**CITY OF MCMINNVILLE  
PLANNING DEPARTMENT**  
231 NE FIFTH STREET  
MCMINNVILLE, OR 97128

**DECISION, FINDINGS OF FACT AND CONCLUSIONARY FINDINGS OF THE MCMINNVILLE HISTORIC LANDMARKS COMMITTEE FOR THE APPROVAL OF ALTERATIONS TO A HISTORIC LANDMARK LOCATED AT 806 SE DAVIS STREET**

- DOCKET:** HL 4-20 (Certificate of Approval for Alteration)
- REQUEST:** Approval of alterations to an existing historic landmark and building that is listed on the McMinnville Historic Resources Inventory as a “Significant” historic resource (resource number B540). The proposed alterations include the removal of two non-original additions on the rear of the structure, removal of an existing exterior chimney, and relocation of windows and doors on the rear façade where the additions are proposed to be removed.

The proposed alterations are identified in the submitted building elevations identified below:

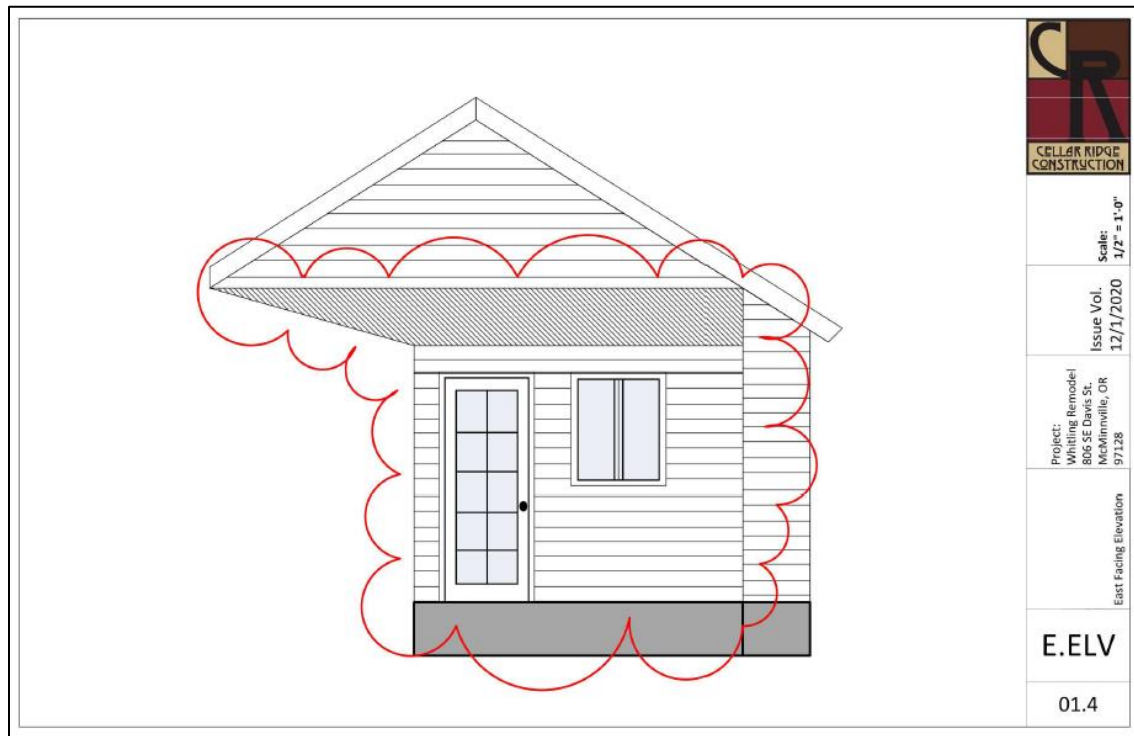
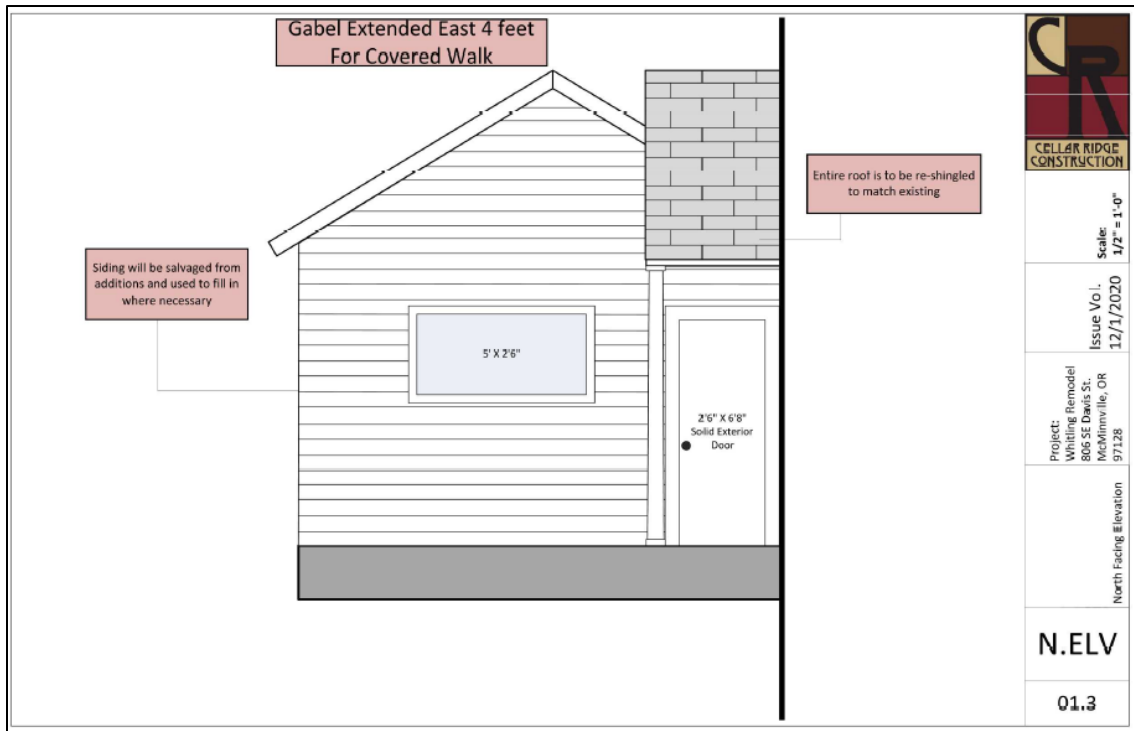
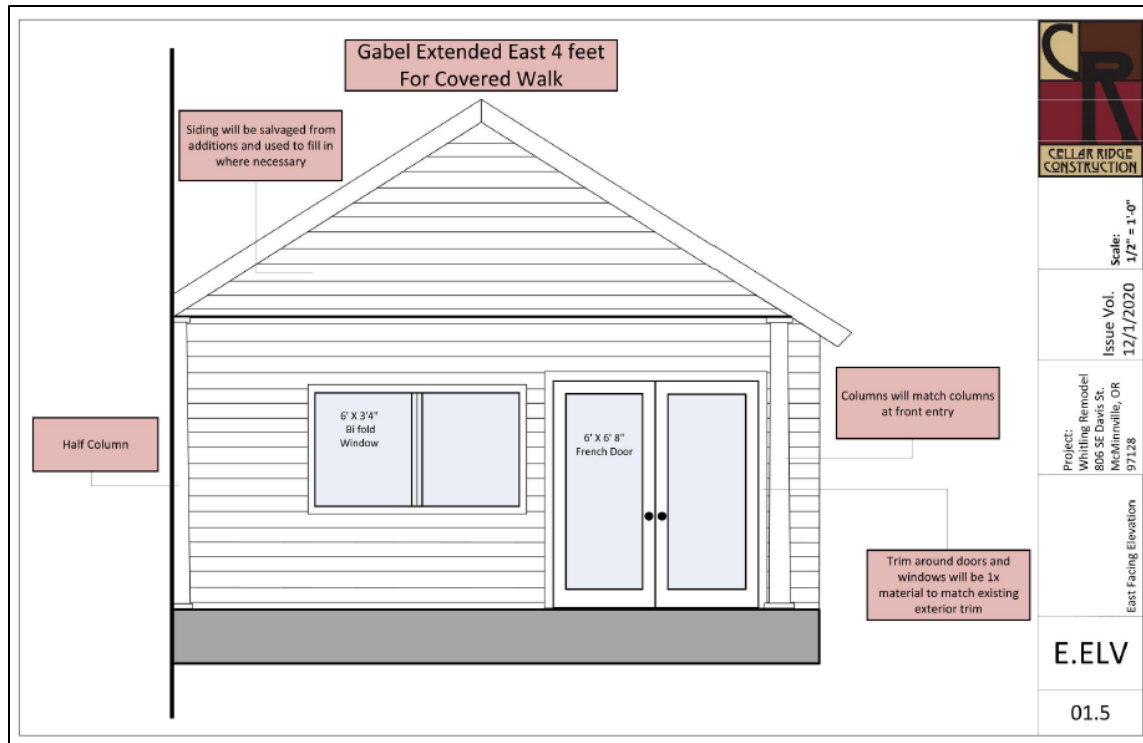
**FINDING: SATISFIED WITH CONDITIONS #1, #2, AND #3.** The City partially concurs with the applicant’s findings. The City finds that evidence was provided to support the proposed removal of the porch additions, based on evidence that they were added at a later date and not original to the building or property. The porch additions are not associated with the documented historic character of the property and therefore, their removal does not result in the loss of a feature or space that characterizes the property. The footprint of the historic building after their removal will more closely resemble the original footprint and form of the building.

The exterior of the building, after the removal of the porch additions, is also proposed to be altered. The original east facing façade, as it exists underneath the existing porch addition, will be altered by the relocation of the door and enlargement of the door opening for French doors. The east facing façade will also include a new opening for a new window, and is also proposed to include an extension of the gable roof to allow for a small covered area underneath the extension of the gable roofline. The north facing façade, as it exists underneath the existing porch addition, will be altered by the replacement of the existing door, the removal of one small window, and the addition of a new window more centrally located within this north facing façade.

The City finds that the proposed removal of the exterior chimney is not supported, and that the removal of this feature would result in the loss of historic character of the building. While the chimney is not specifically referenced in the Historic Resources Inventory description of the historic resource, the chimney appears to be original and therefore provides historic character as an original feature still made of original brick materials. No evidence was provided that the

1. That the new windows and doors be wood to be consistent with the historic materials that existed on the historic resource and to protect the historic character of the historic resource. The windows and doors shall be finished with wood trim that matches the size and dimension of the existing window trim on the remainder of the house. The more decorative exterior window headers that exist on the front building façade do not need to be included in the window and door trim associated with the new windows and doors.

2. That the siding on all final exterior building facades be a wood, horizontal siding that is consistent with the siding on the remainder of the home. As stated in the application narrative, the applicant shall attempt to save any matching siding from the porch additions being removed to be used in the final exterior building facades.

3. That the exterior chimney be supported and maintained during the removal of the interior fireplace. If the exterior chimney is not able to be supported during the removal of the interior fireplace, the chimney shall be reconstructed on the exterior of the home using the salvaged

1928 Sanborn Map – Sheet 22:

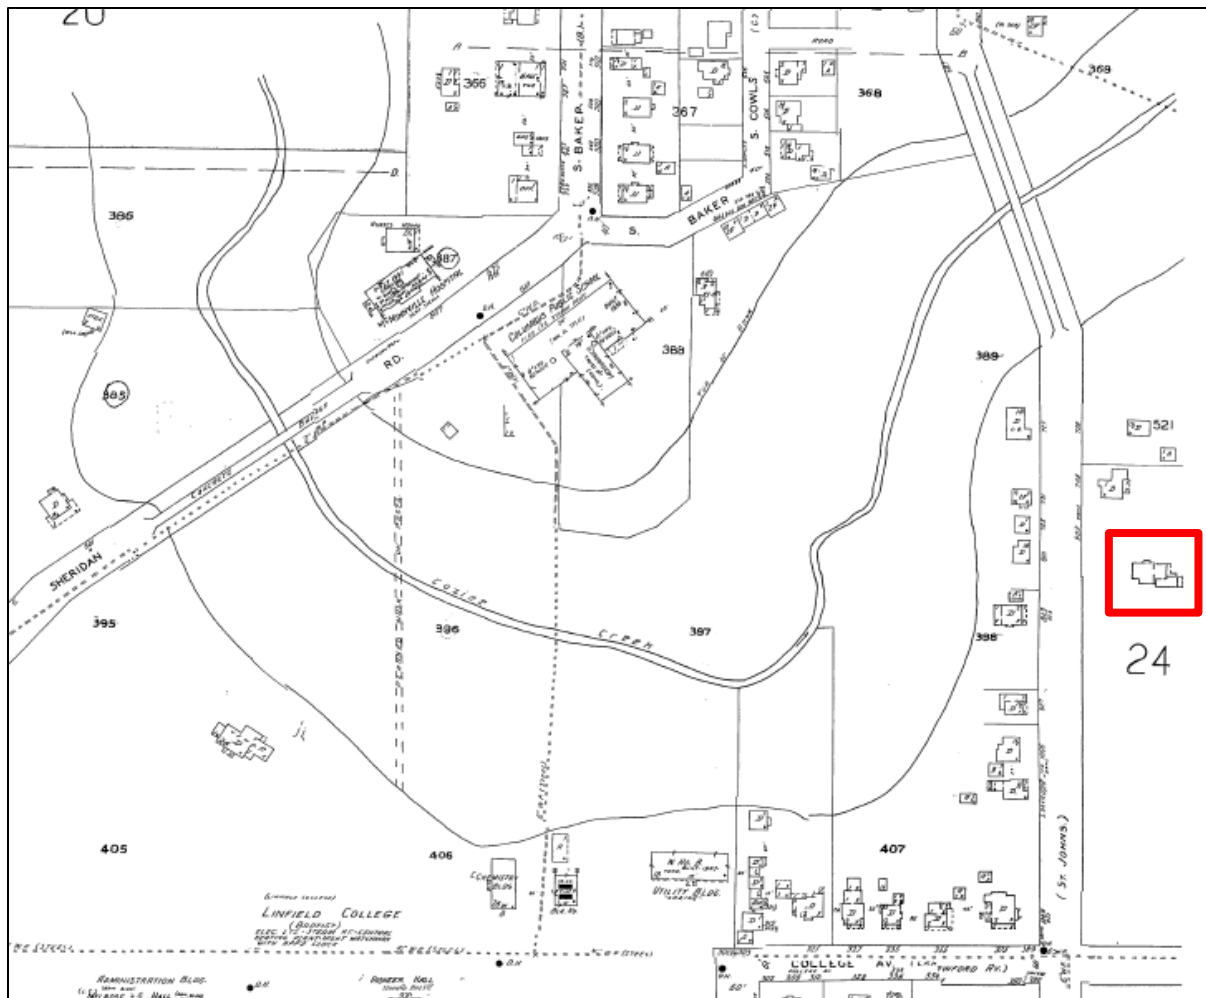
Sanborn maps were reviewed in order to determine whether the additions proposed for removal were original to the building. The first Sanborn map that identifies the area where the subject historic resource is located was in 1928. The historic resource appears to be shown on the 1928 Sanborn map. However, not much detail is provided for the structure, if it is the historic resource in question. The area and the same structure are shown again on the 1948 Sanborn map, but again not much detail is provided for the structure. If these structures on the Sanborn map are

the historic resource in question, the porch additions were not original. The exiting garage south of the main home is also not original, which is consistent with the existing floor plan that shows the garage being attached to a later addition. Based on the Sanborn maps and the evidence provided by the applicant, it is determined that the additions proposed to be removed are not original. The Sanborn maps and the potential reference to the historic resource at 806 SE Davis Street are identified below.
